**Proposal for the revision on Skew budget  
for PMD portion  
(40GBASE-LR4, 100GBASE-LR4/ER4)**

**IEEE P802.3ba Interim Session  
New Orleans, January 12-16, 2009**

# Skew budget proposal for PMD portion

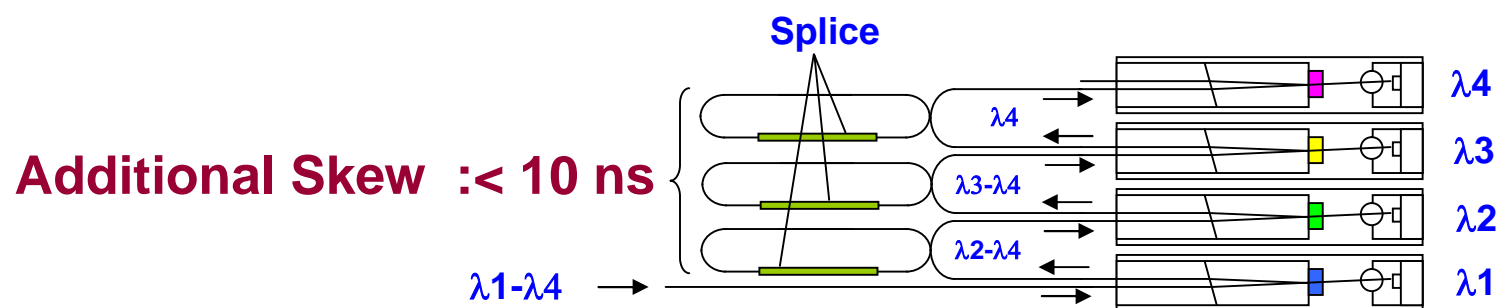
- In case of Hybrid type Tx and Rx (2port O-MUX+TOSA and O-DEMUX+ROSA), the relaxation of skew due to cascaded fiber connection is necessary.
- The additional skew of 10ns for each Tx and Rx is proposed.

## Reconsider for skew budget for PMD portion

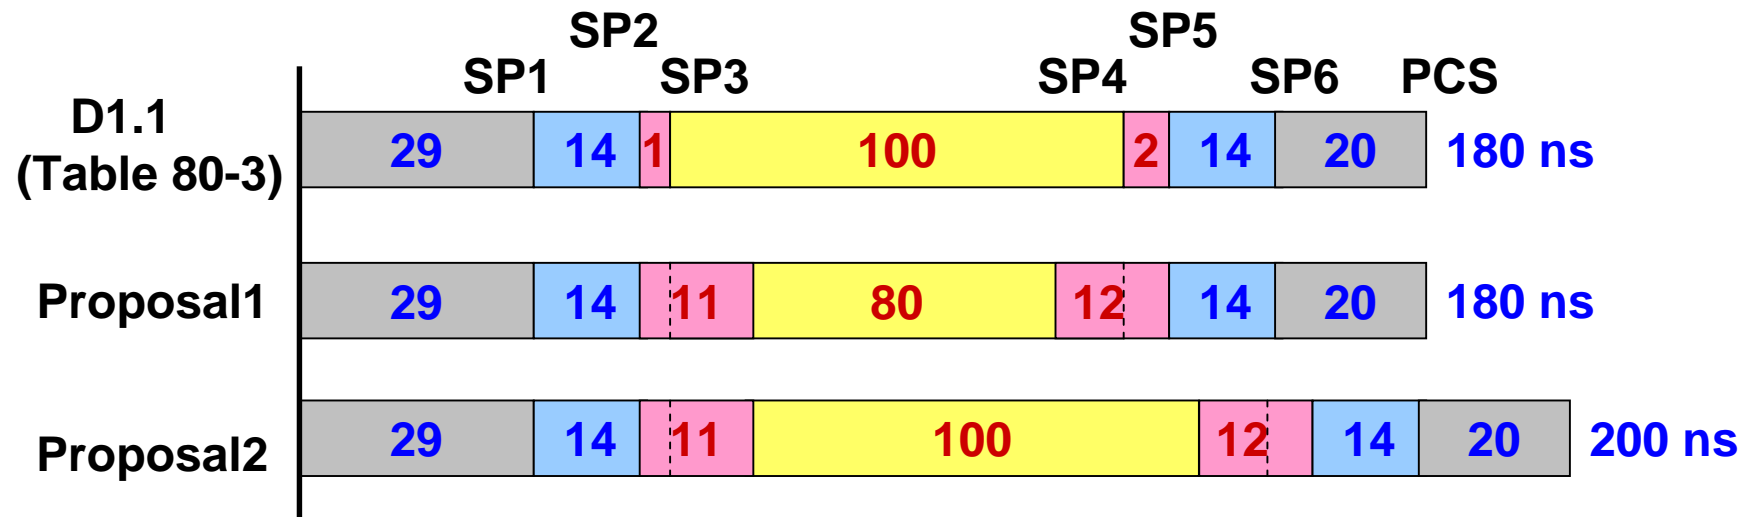
Budget for PMD	Draft 1.1	Proposal
SP3-SP2(Sending)	1ns (44ns-43ns)	11ns
SP5-SP4(Receiving)	2ns(146ns-144ns)	12ns

There are two options for the skew diagram design, which is specifically shown in below.

## Skew definition points (SP5 & SP6) reconsidered.

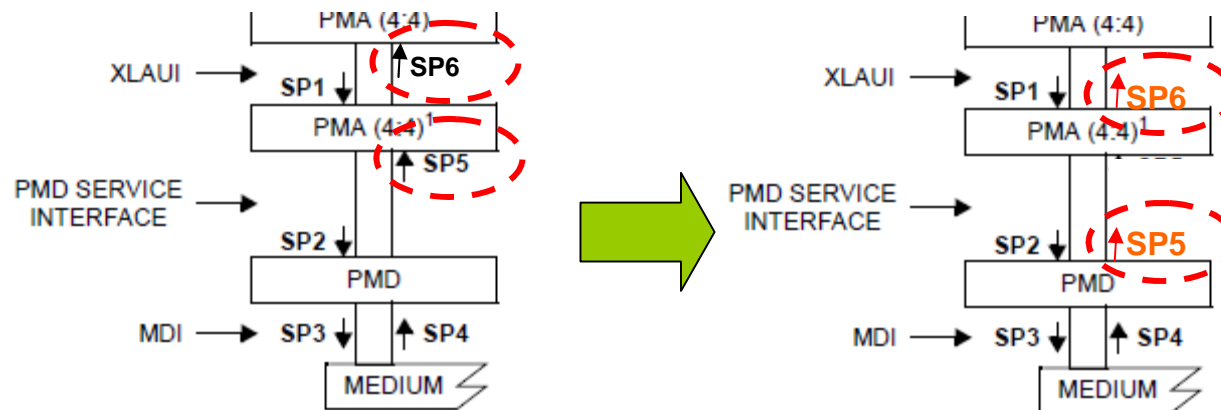
SP5 & SP6 definition points should be changed to the output portion of PMD & PMA respectively, considering the hardware interface among PMD, PMA and the upper layer.

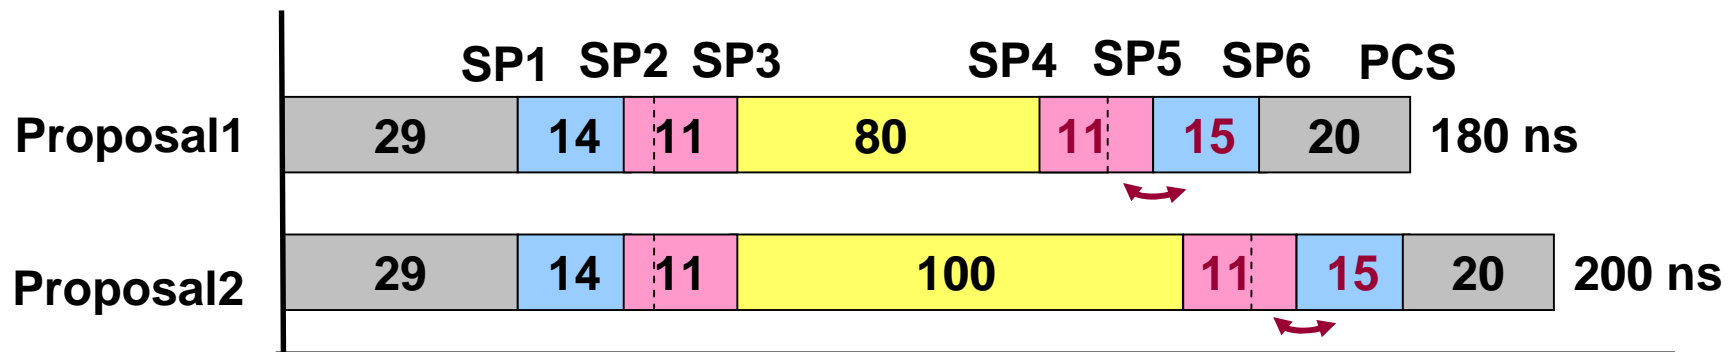
Reflected budget is as follows.
